# VALUE ENGINEERING STUDY

Tres Rios  
Phoenix, AZ

## Final Report

September 2000

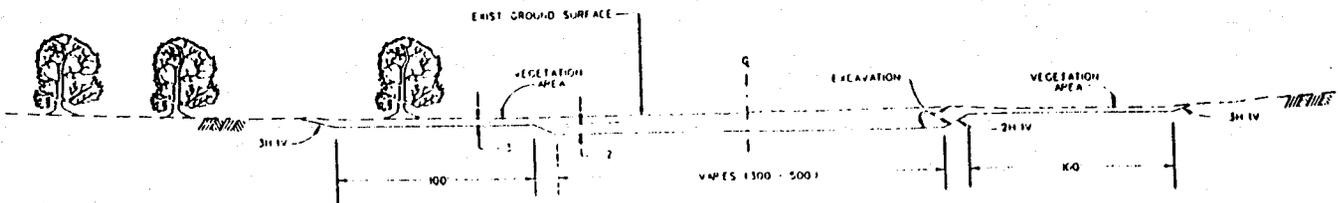
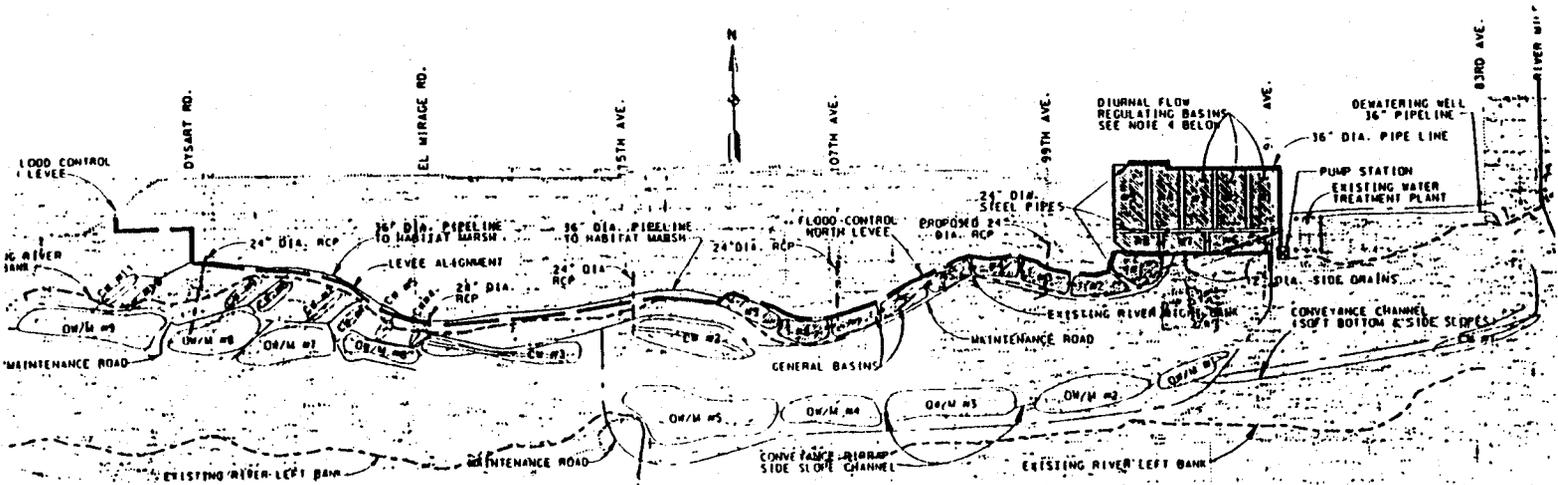
The main objective of this recommendation is to explore the impact of minor changes in elevation over large areas.

The depths are currently set at three feet for the shelves with an additional two feet at the pools. The depths should be set based on the desired aquatic habitat. The depths should be varied throughout the open water marsh with deeper holes and habitat in the pools and on the shelves. The effect of shading by the cottonwood/willow should be incorporated into the design. The required habitat conditions can be developed with a sloping, pitted bottom.

While the one foot reduction is arbitrary, so is the proposed depth in the original concept. The point of this recommendation is to illustrate that a relatively minor adjustment in the depth of these pools results in significant cost savings. Rather than set an arbitrary depth, the value team recommends that serious consideration be given to the depth necessary to support the habitat that is desirable to this project.

From an O&M perspective, the value team does not believe a one-foot change in pool depth will have a noticeable change to the required O&M effort. To account for sediment load, the pools would have to be significantly deeper. This is not practical or cost effective.

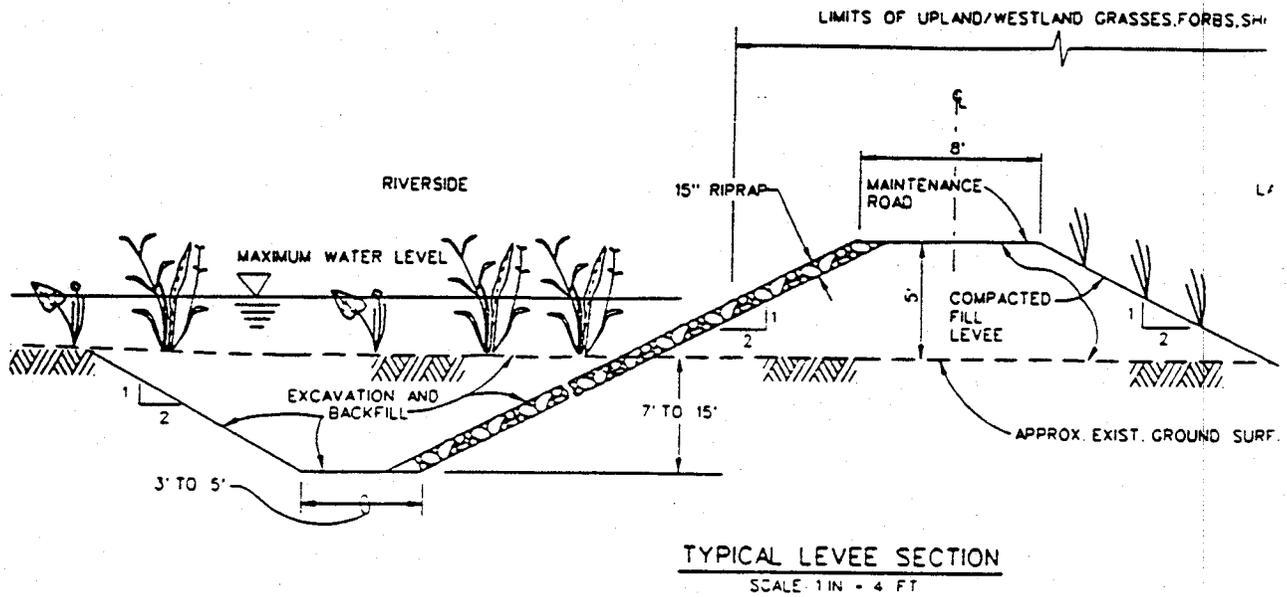
Based on the criteria stated in the EM, there is an opportunity to change the slope protection. For this project, the flood duration is short, maybe three weeks against the levees. The material is not susceptible to erosion. Estimated erosive velocities are estimated to be greater than three fps. The riverside is protected by timber stands. The levee is relatively straight except near the western end at the turn out. The slope is relatively flat. The recommended slope is 4H:1V. The Holly Acres levee is armored with cobbles and is steeper and has performed well. The project will be monitored.

The detail as shown for the original concept requires the excavation of natural material to construct the turndown for the riprap. The excavated material is then backfilled in the trench. It is difficult to backfill against the riprap on a 2 to 1 slope. The contact of the riprap and backfill is the weakest point. If scouring is initiated, it will probably be at this location and scour down the face of the riprap removing the backfill.

The core of the levee remains the same to protect from seepage and piping.

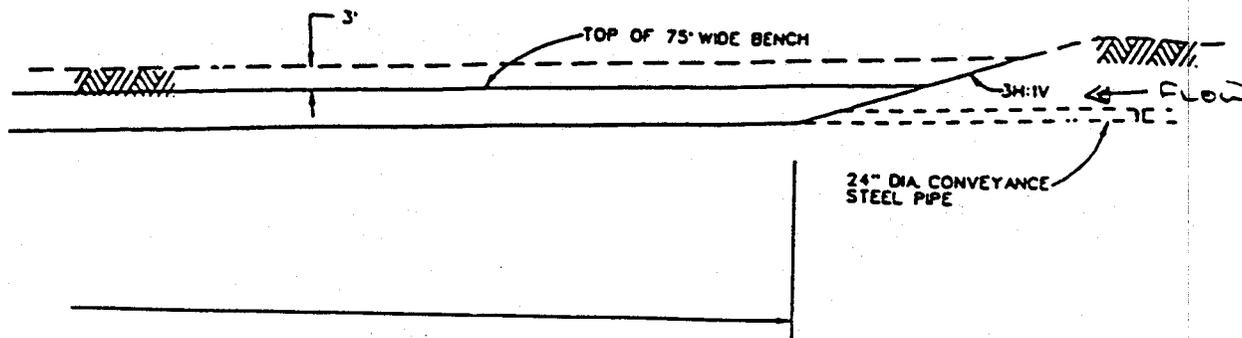
The proposed change replaces most of the pipeline with a soft-bottom trapezoidal channel (irrigation ditch) with a depth of approximately 2-3 ft below finished grade. The channel follows the inside (south) bank of the north levee. The construction requires excavation, shaping and selective backfill. The channel could be formed to resemble a natural stream bed. A pipe is still required beneath the Holly Acres development due to a lack of space between the development and the levee that exists in this reach.

The necessity of piping beneath Holly Acres should be evaluated during design.

Increased maintenance of the channel was not considered a relevant issue. The channel to the west end of the project is only needed under the original concept to establish the riparian corridors. If the channel should fail within five years, the irrigation company's water would short circuit to the river. This would simply provide the opportunity for new riparian corridors. The value team does not consider this a failure of the system. The irrigation company would still get their water and the cottonwood/willow corridors would be into groundwater. Thus, the channel should require little to no maintenance to accomplish the required function.

F-75

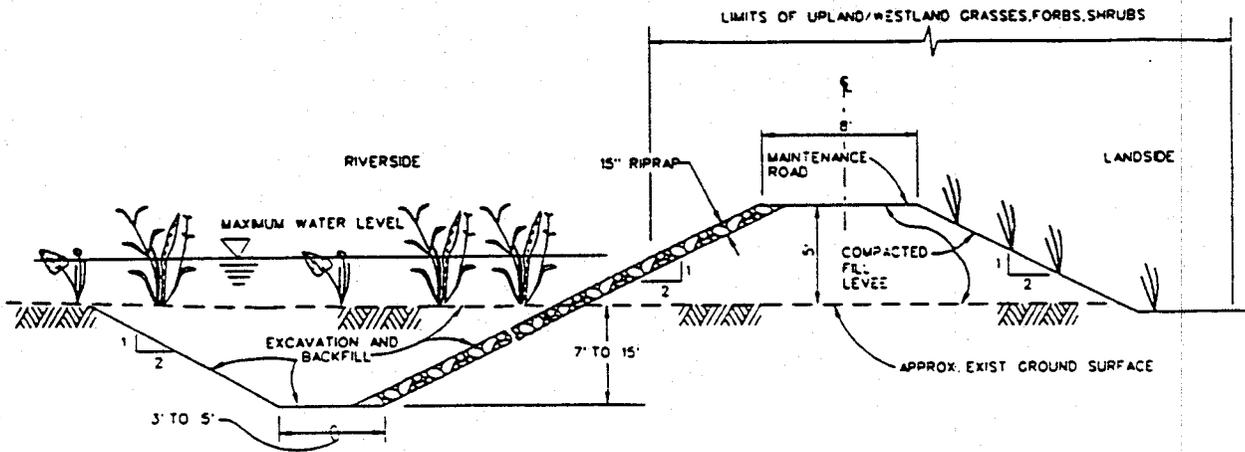
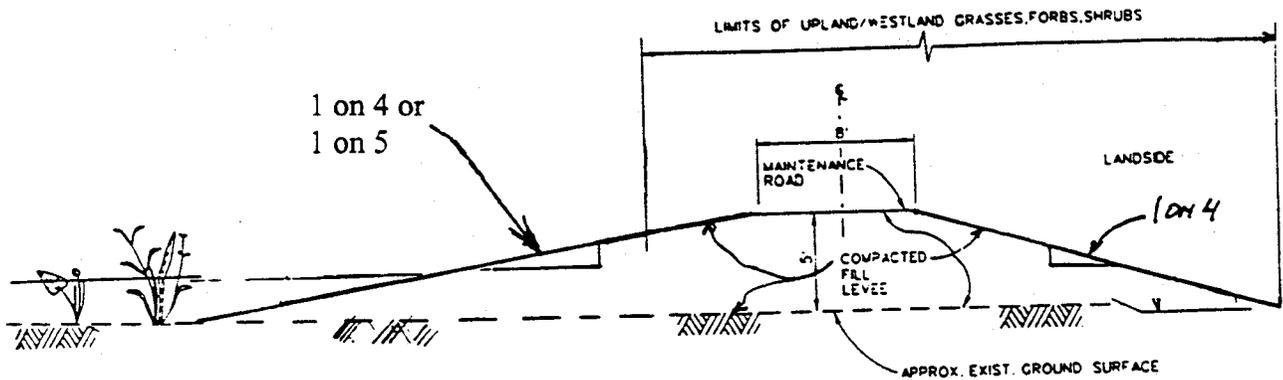
The intent of this recommendation is to provide a beneficial use of some of the excess excavation by putting additional material on the north side levee. This would be done in such a manner to make the levee look more like a natural landform.

The value team feels that the levee flood protection would be more appealing to the local residents if they were constructed to a more natural appearance. This recommendation would use more of the excavated material from the project, thus requiring less stock piling. With a broader levee, the riprap and riprap toe down would not be required. The cottonwood/willow riparian corridor planted at the toe of the levee would provide protection during the high flows when the levees would be in use.

PROPOSAL NO.: H-02

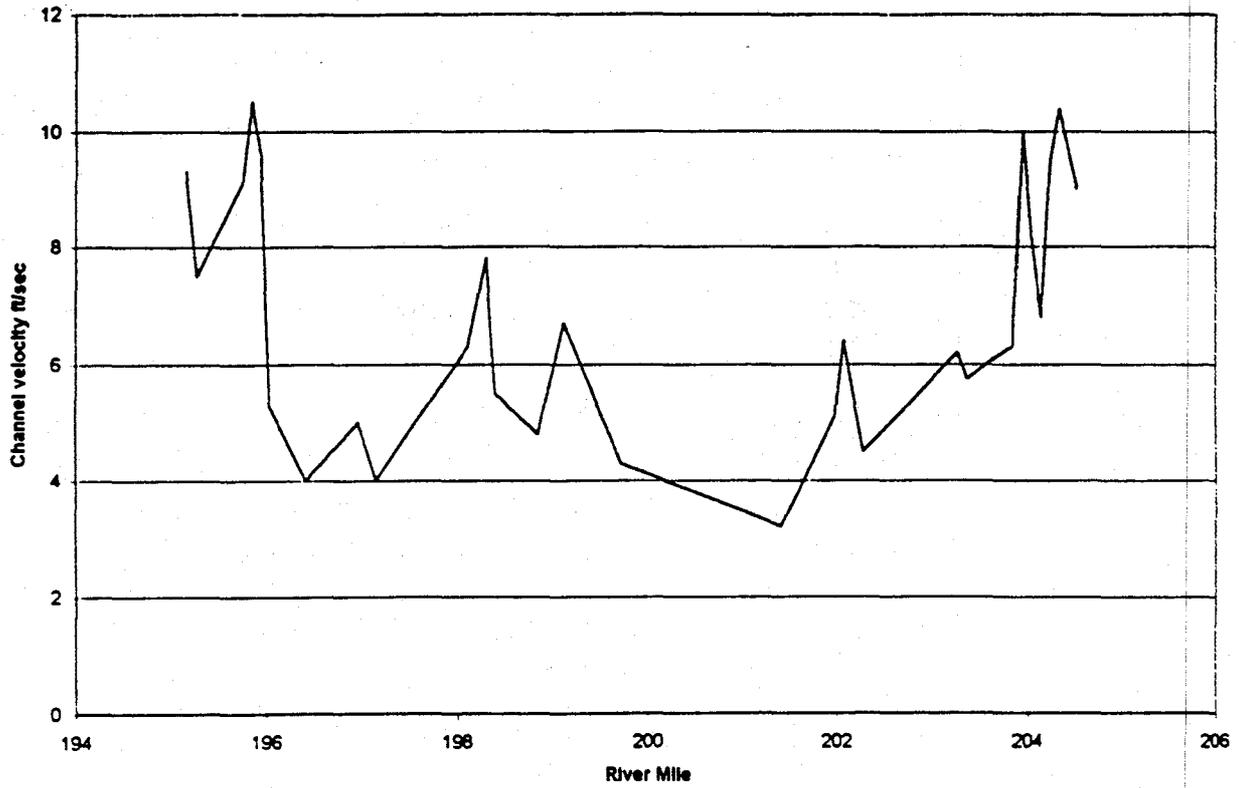
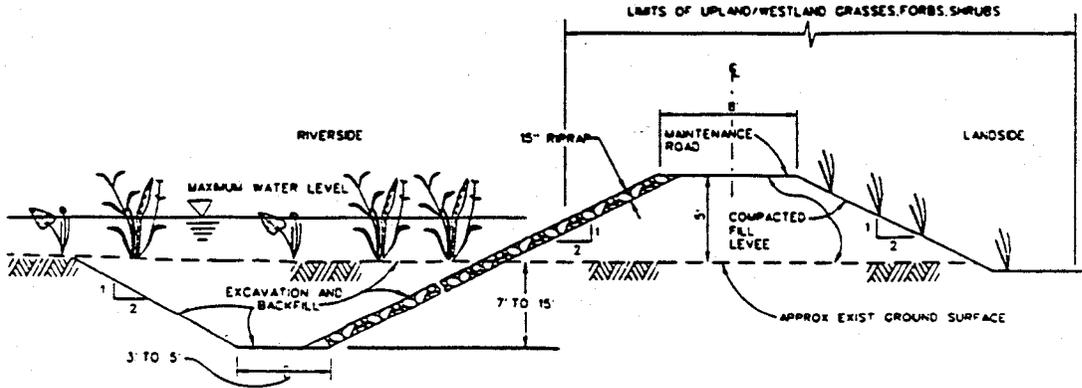
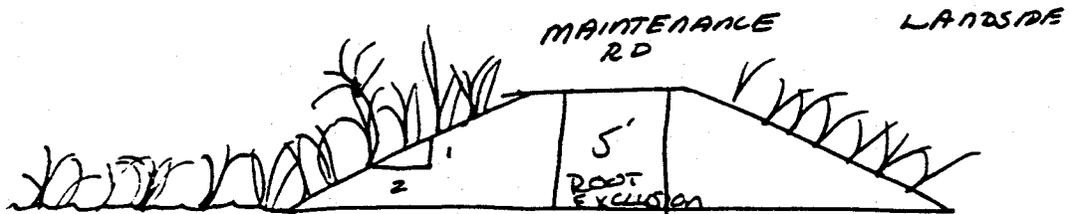
Bioengineering methods range from purely vegetative: live fascines, brush layering, live staking and simply dense planting to hybrid structures including engineering materials such as geogrid, riprap or geoweb.

In this project, a purely vegetative approach would provide adequate slope protection while adding considerable upper riparian habitat. Mesquite, quailbush, and rabbitbush vegetation would work well. The practice is to plant young rooted stock on the slope and supply drip irrigation until established. Vegetated slopes are generally self maintaining and are replanted only on areas where plant loss causes a large gap in cover.

As an alternate, the levee slope could be covered with landscape fabric to prevent penetration, more soil added to flatten the slope and then planted.

H-25

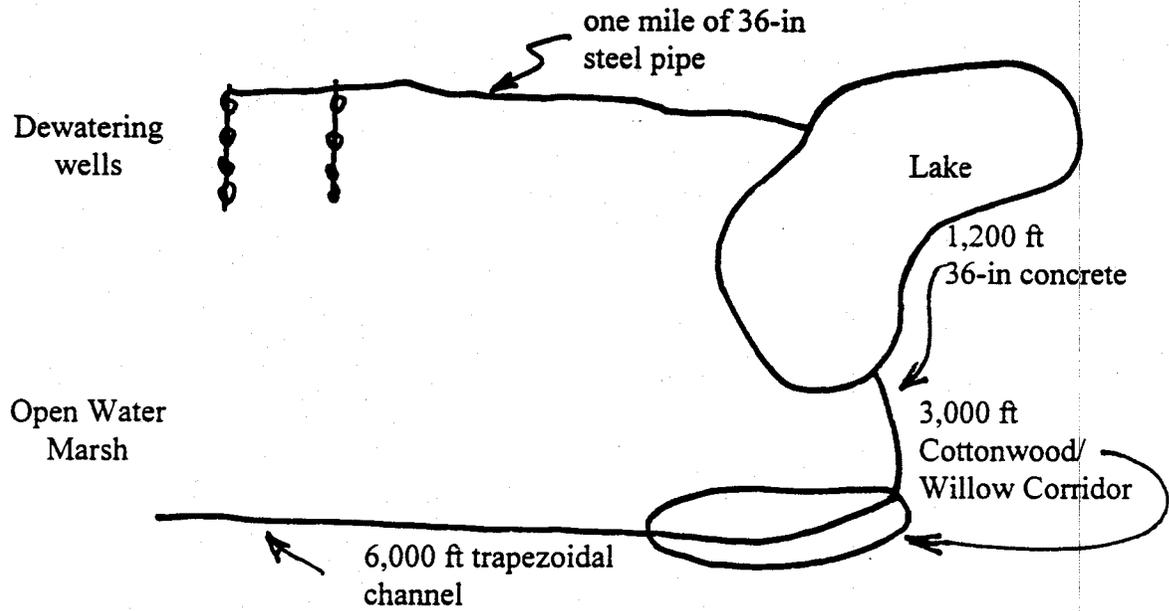
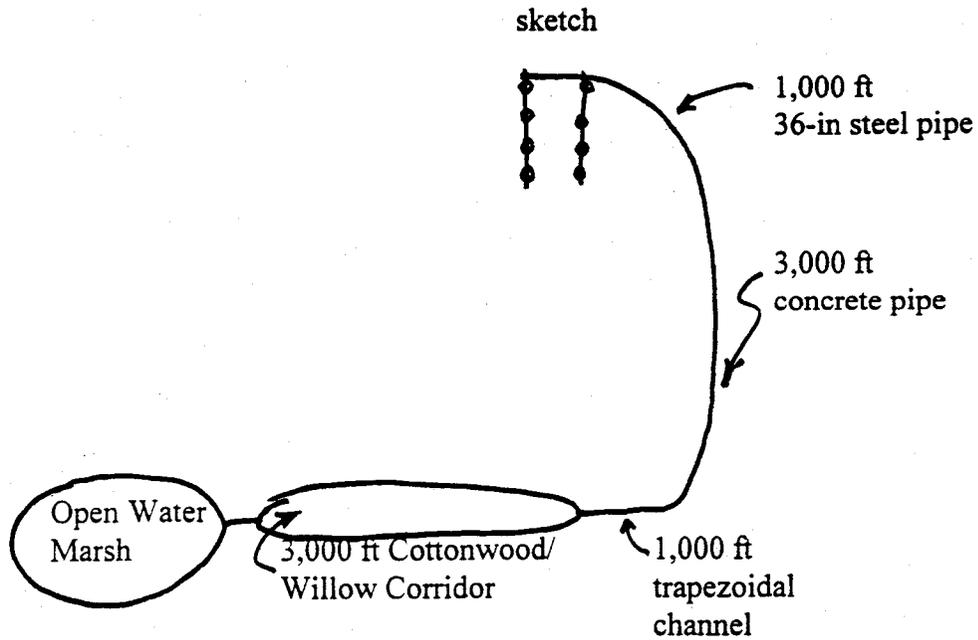
The proposed change reduces the length of the dewatering well water conveyance system by 50 percent and thus reduces total construction. The changes do not delete any habitat areas and maintains the habitat unit goal. The changes accomplish the goals proposed for the Tres Rios south side features.

The proposed changes do not provide for the exchange of water in the gravel pit lake. Water from the proposed upstream projects could be directed into the gravel pit lake in the future and would provide water exchange in the lake.

H-27

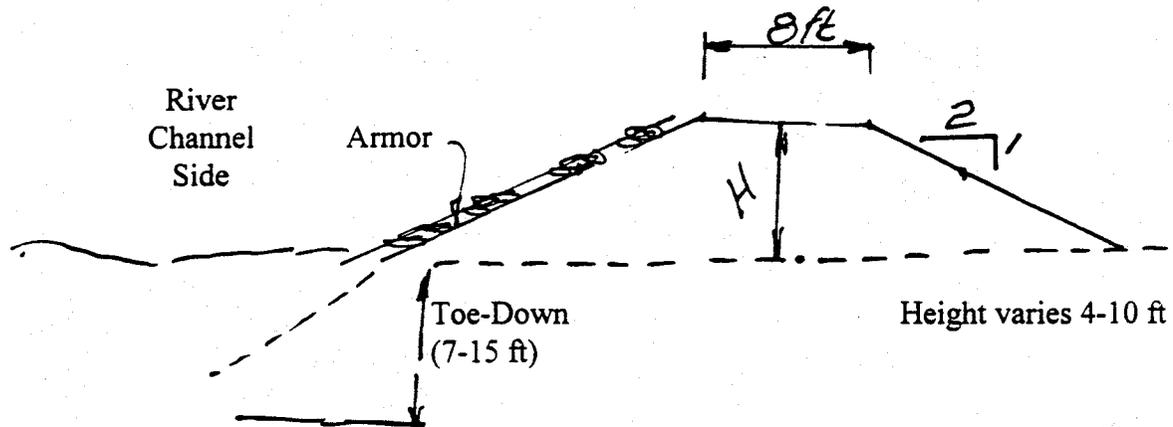
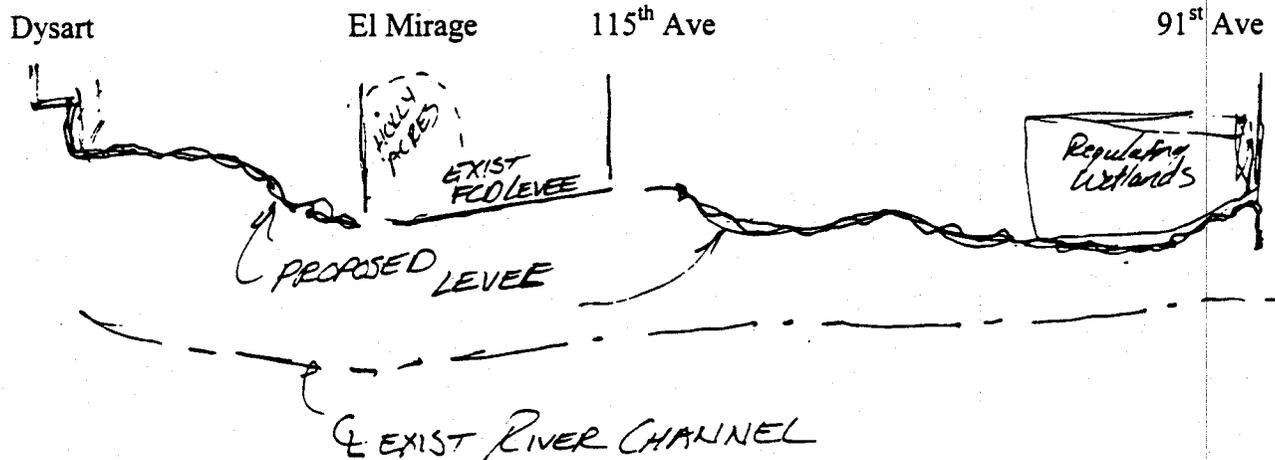
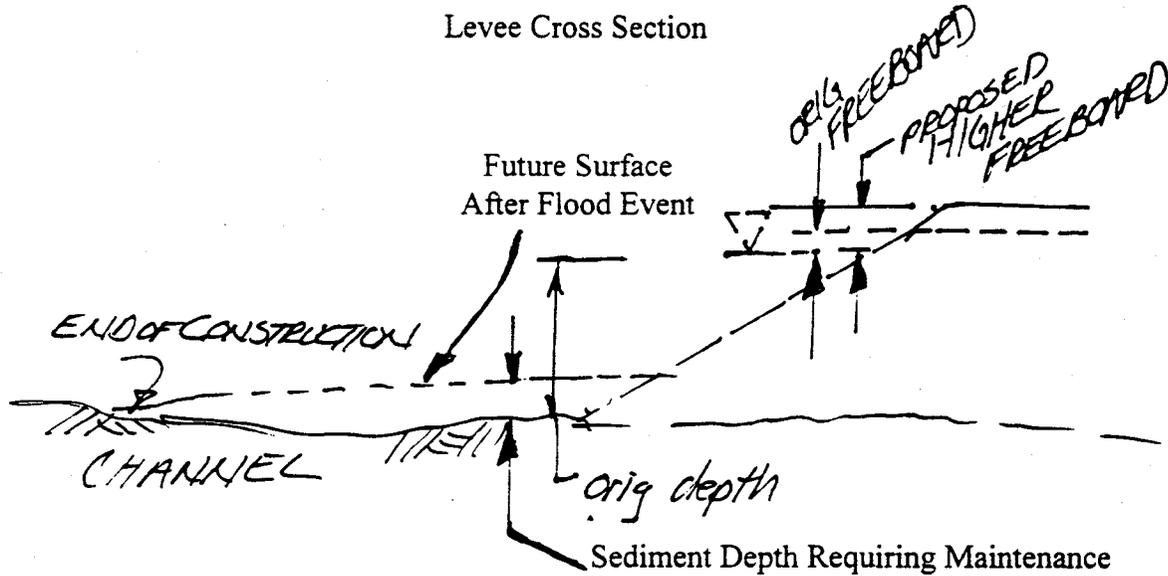
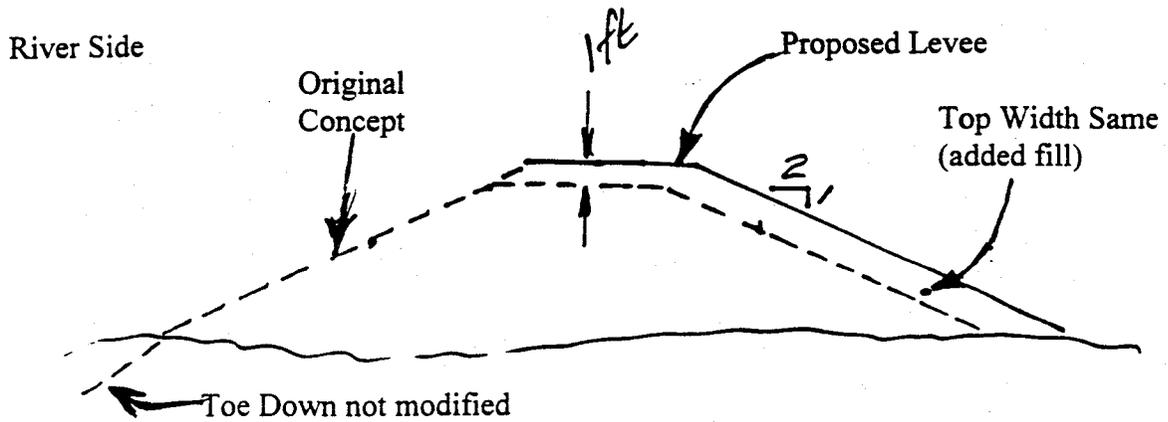
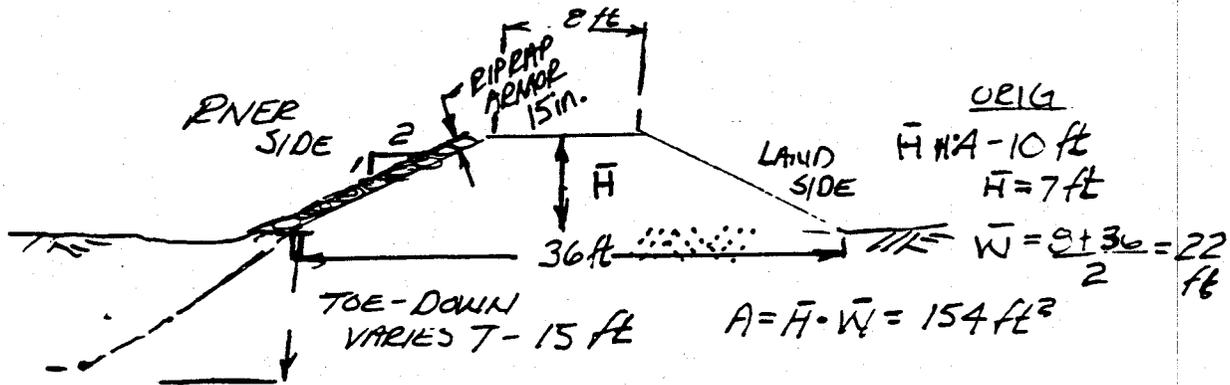
The proposed concept is a higher levee that provides more freeboard. The extra freeboard results in significant benefits. For cost estimating purposes, one foot is assumed as added height.

It appeared unclear to the value team how the proposed change would result in a lower maintenance cost. One team member suggested that increasing the time period between maintenance activity would be a burden to the maintenance agency – FCD. He suggested FCD would try to plan annual maintenance efforts at a frequency close to annually would be most cost effective. FCD disagrees. By raising levee height, freeboard is added to the levee. All added freeboard can be used to contain sediment that washes into the river during flood events. FCD has made the point that sediment transport is an important parameter in the project. First, it has not been analyzed. Further, it will be very difficult to analyze and predict accurately as there are three rivers involved in the analysis.

Considering the difficulty in predicting depth of sediment, more freeboard is warranted. What if sediment depth is far greater than anticipated? The project could lose 100-yr frequency protection on the levee shortly after construction, requiring a big maintenance effort to restore it. It is prudent to build the project with a safety factor to prevent this scenario. In this case, this safety factor is not costly. Currently, the project shows a great surplus of excavated soil. Rather than wasting it, the soil can be put to beneficial use in the levee. There is essentially no hauling to bring it to the levee because it is on site.

As for annual, periodic trips to the river for maintenance, it is to be avoided. The point of the project is river management – not maintenance. By staying out of the river, maintenance costs are reduced. The feasibility report greatly under-estimates maintenance. Mobilization and labor are the biggest components. More trips to the river increase these costs. The proposed change lowers life cycle costs.

Higher freeboard increases  
this depth, decreasing periodic  
maintenance
